PRODUCT SAFETY RECALL

SUBJECT: Power Seat Wiring Harness Chafing

MODELS: 2013 Chevrolet Malibu
Equipped with 8-Way Power Front Seat Feature (AG1/AG2) and without
Memory Seat Feature (A45)

3642530

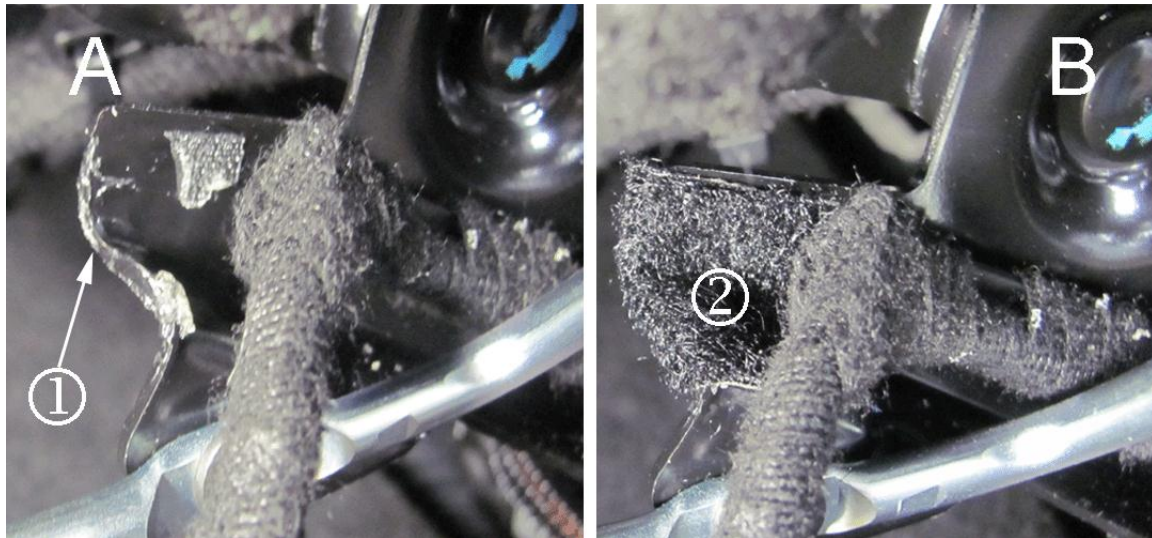
3. Examine the seat wiring harness (4) to determine if it has a harness protector (1), tie strap (3) and Velcro tape patch (2) on the front edge of the seat frame.
 - If the harness protector, tie strap and Velcro tape patch are present, no further action is required. Install the driver and/or passenger seat outer recliner finish cover. Refer to *Driver or Passenger Seat Outer Recliner Finish Cover Replacement* in SI.
 - If the harness protector, tie strap and Velcro tape patch are NOT present, proceed to step 4.
4. Inspect the seat wire harness wrapping for damage. If the wiring insulation becomes worn or cut through to the conductor a short to the grounded seat frame may occur. Repair wire harness, if necessary. Refer to the appropriate wire repair procedures in SI.

5. Cut a 25 mm (1 in) piece of Velcro tape. Use the loop side of the tape for the repair.

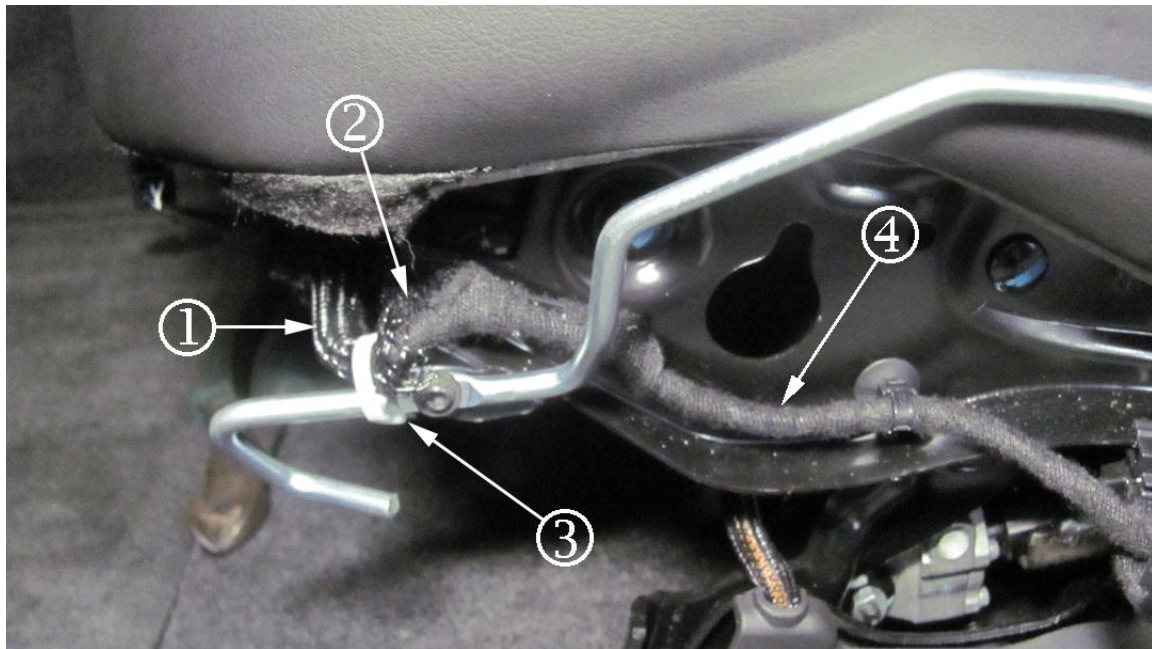
6. Apply the loop side of the Velcro tape (2) around the seat frame edge (1) as shown in photograph. 'A' portion of photograph shows a seat frame edge without Velcro tape. The 'B' portion of the photograph shows the Velcro tape applied to the seat frame edge.

7. Wrap the protector sleeve (1) round the wire harness (4) in the area that will come in contact with the seat frame edge.
8. Install the tie strap (3) around the wire harness (4) and metal bar to secure the protector.
9. Cycle the front seat height and tilt adjustment 3 full times and inspect afterwards that the reworked area is still intact.
10. Install the driver and/or passenger seat outer recliner finish cover. Refer to *Driver or Passenger Seat Outer Recliner Finish Cover Replacement* in SI.
